CITY OF SAN ANTONIO

Re: Woodridge Village

POADP # 28-B

The City Staff Development Review Committee has reviewed Woodridge Village Subdivision Preliminary Overall Area Development Plan # 28-B. Please find enclosed a signed copy for your files. Although your plan was accepted, please note the following:

WOODRIDGE VILLAGE, UNITS 8A & 8B
 PLANNED UNIT DEVELOPMENT
 PUD / POADP

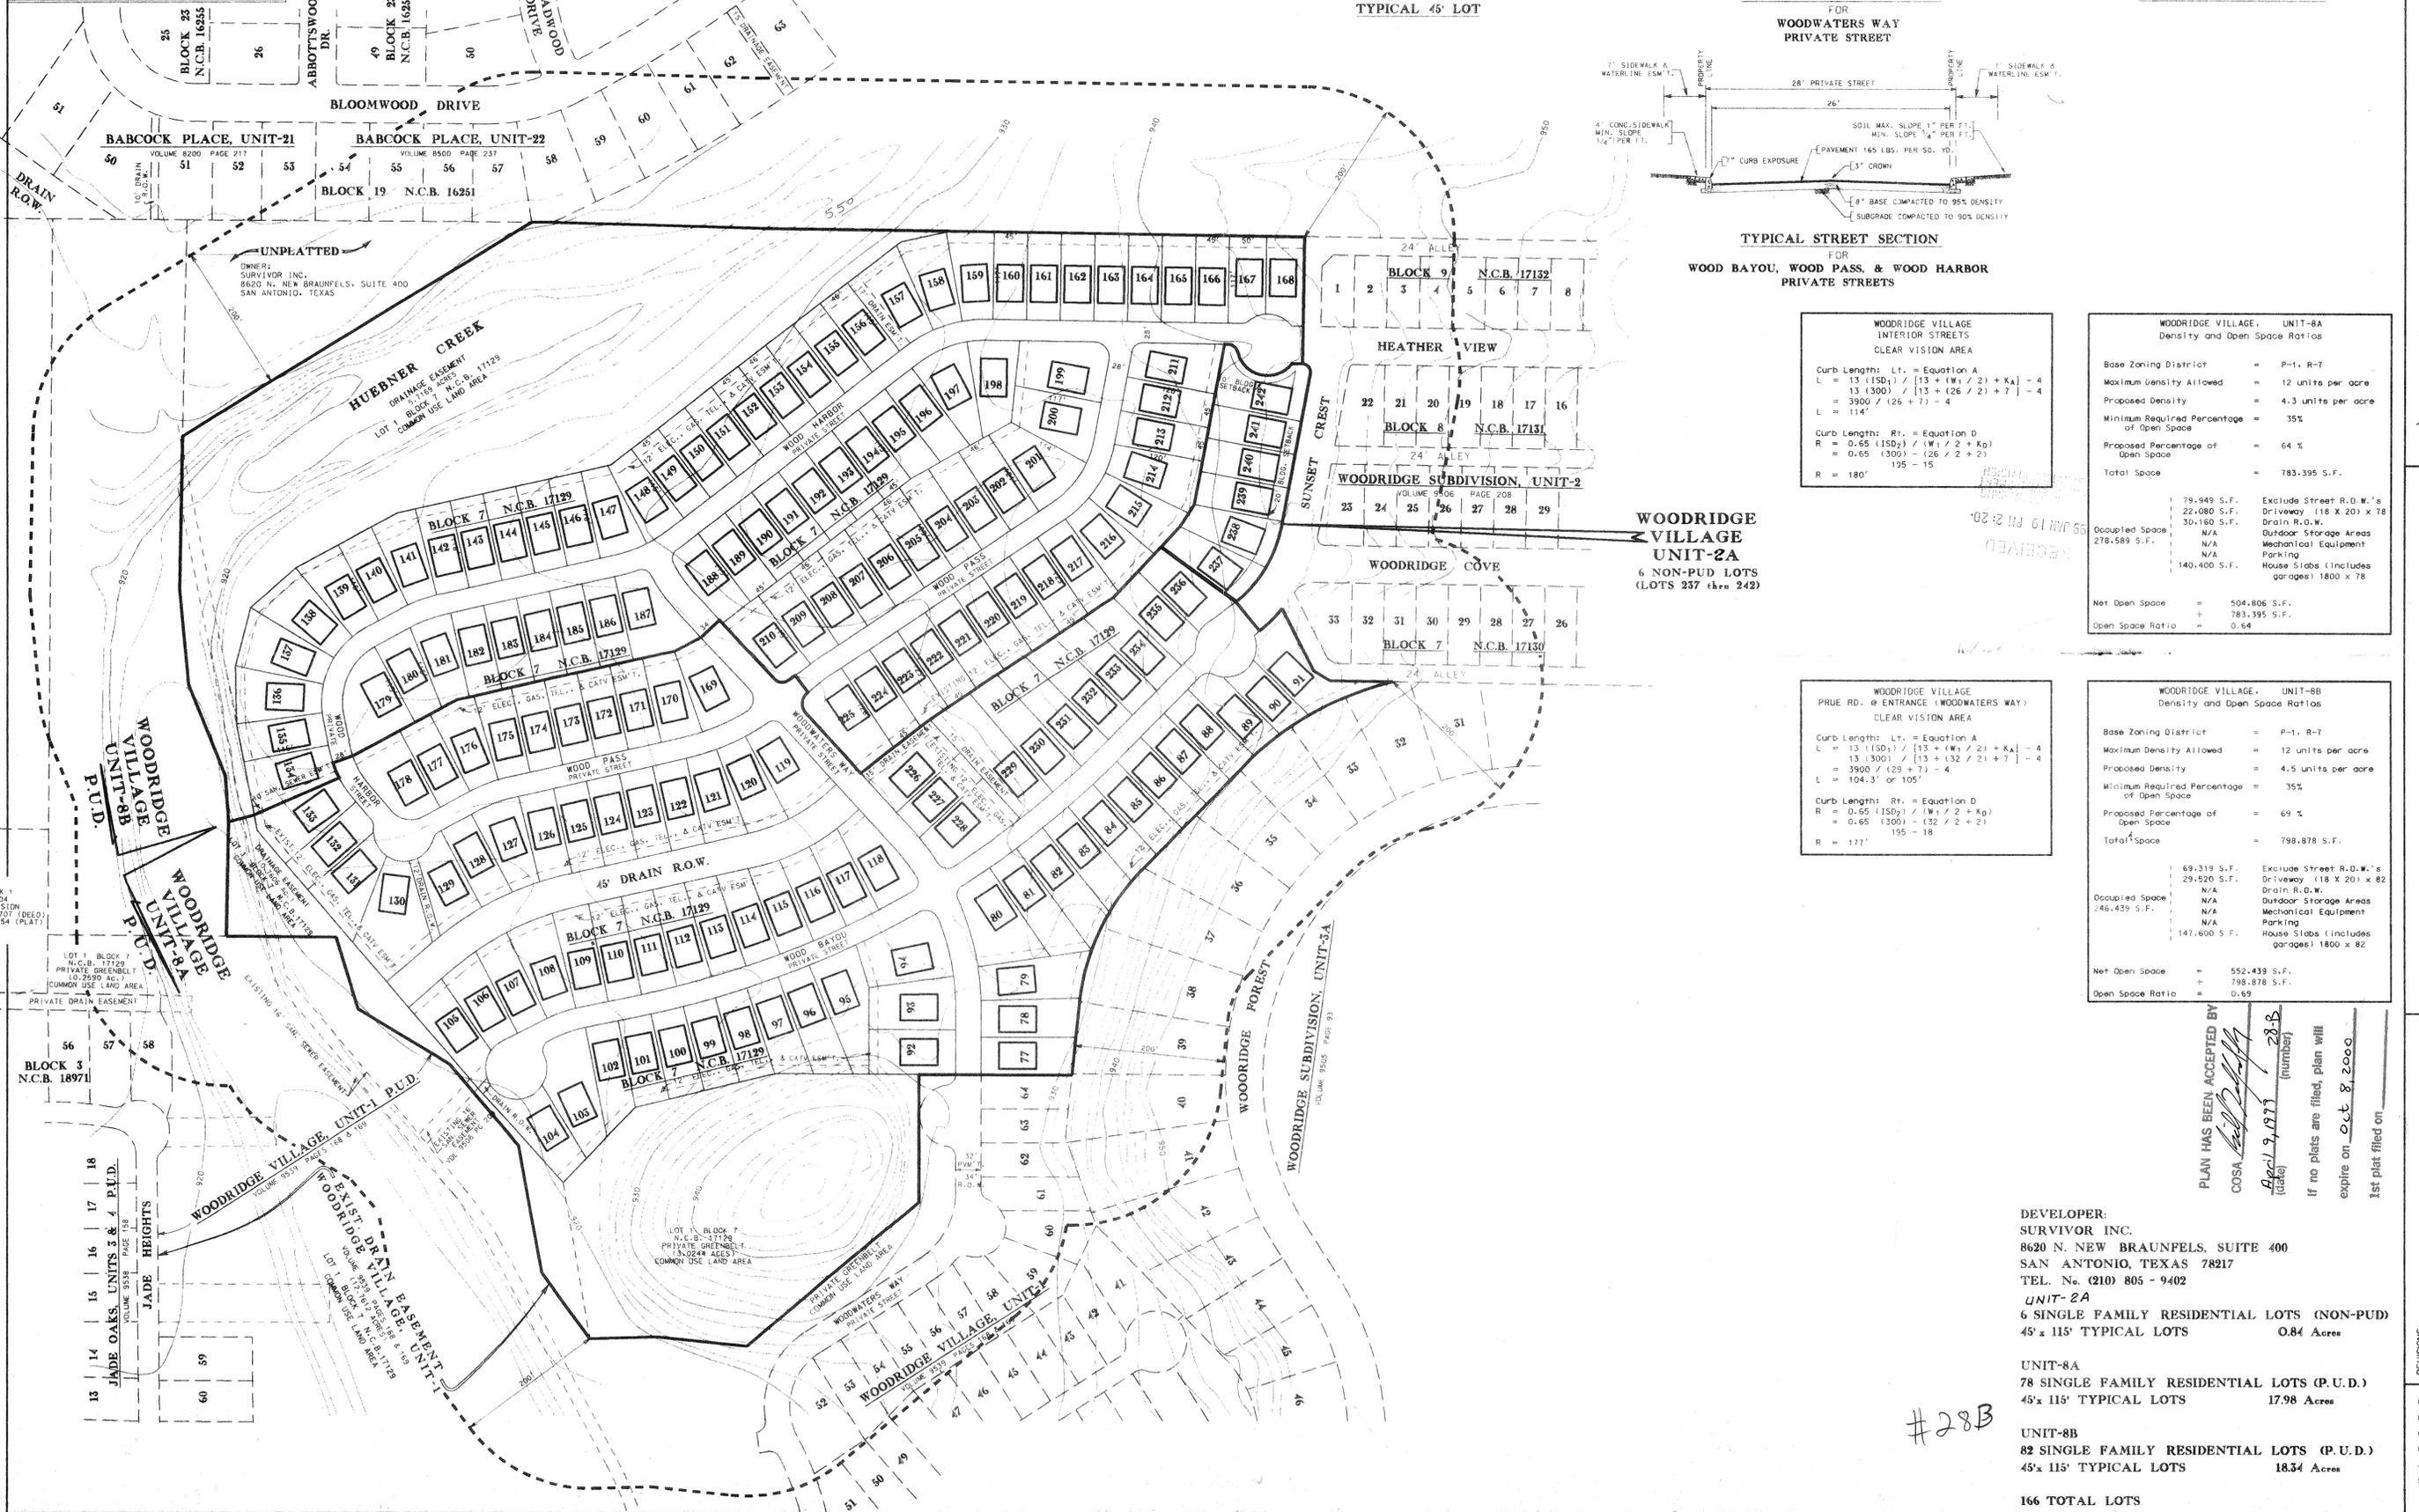
- Based on the topography, a Flood Plain Study and drainage review will probably be required during the platting process.
- This development will need to comply with tree preservation ordinance #85262. For information about these requirements you can contact Building Inspections at 207-7102.
- It will be expected that you will plat all of the property depicted in your POADP, to include: floodpains, drainage areas and open space.
- Emergency access to the PUD will need to be provided at the end of Sunset Crest.
- I would encourage you to work closely with the school district, so that they can plan accordingly.
